FAA
Aircraft Certification Service

SPECIAL AIRWORTHINESS
INFORMATION BULLETIN

SAIB: SW-09-44

SUBJ: Cabin door

Figure1: Addition of rods to hinge pin receptacles per the service bulletin

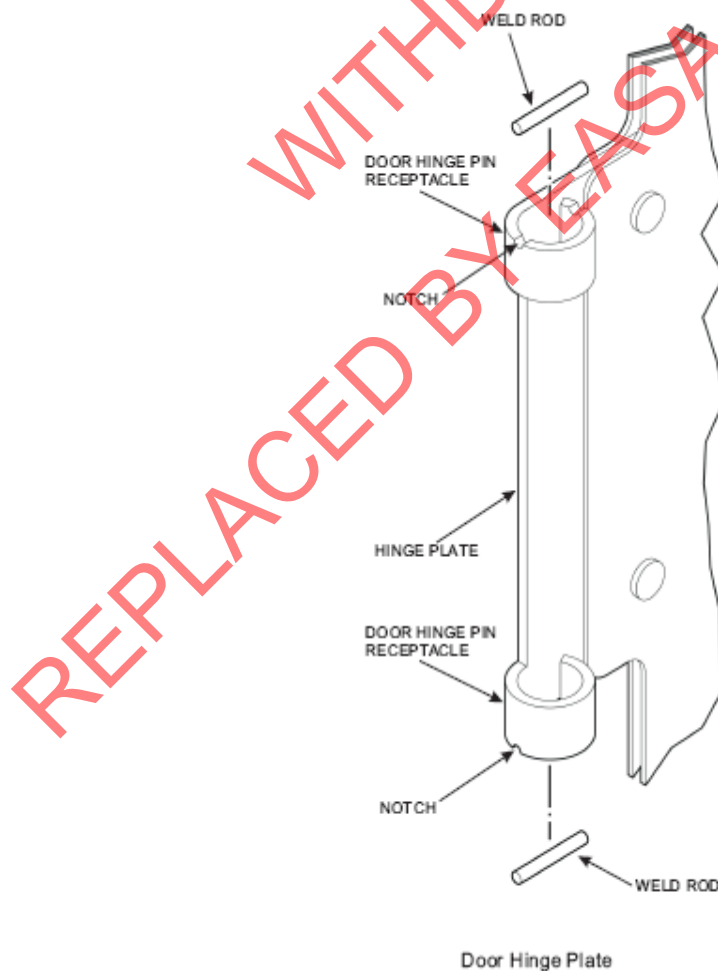
Since 2005, there have been several occurrences of the cabin door detaching from aircraft due to the serrated hinge pins coming off from the door hinge pins, allowing the door hinge pins to separate from the hinge pin receptacles on the cabin door. In December 2007, a cabin door was reported separated from an aircraft in flight as a result of separation of the serrated hinge pins from the door hinge pins. Schweizer decided a "fail safe" device was needed to preclude any future door losses, and the production hinges are now manufactured with caps to replace the open ends of the hinge pin receptacles. For those aircraft in the field, Schweizer issues service bulletins to provide an alternate method to retain the door hinge pins within the hinge pin receptacles for all affected aircraft. These service bulletins provide instructions to weld a stainless steel rod on the open ends of the hinge pin receptacles (Figure 1) to prevent the door hinge pins from falling out of the hinge pin receptacles when the serrated hinge pins are lost.

We recommend all owners and operators comply with actions outlined in Schweizer Service Bulletins DB-026, C1B-028 and B-292 (as appropriate). It is recommended to conduct a visual check of the cabin door hinge installation before each flight until implementation of the appropriate service bulletin at the next available maintenance opportunity. The service bulletin action is not required when the new production hinge is installed.
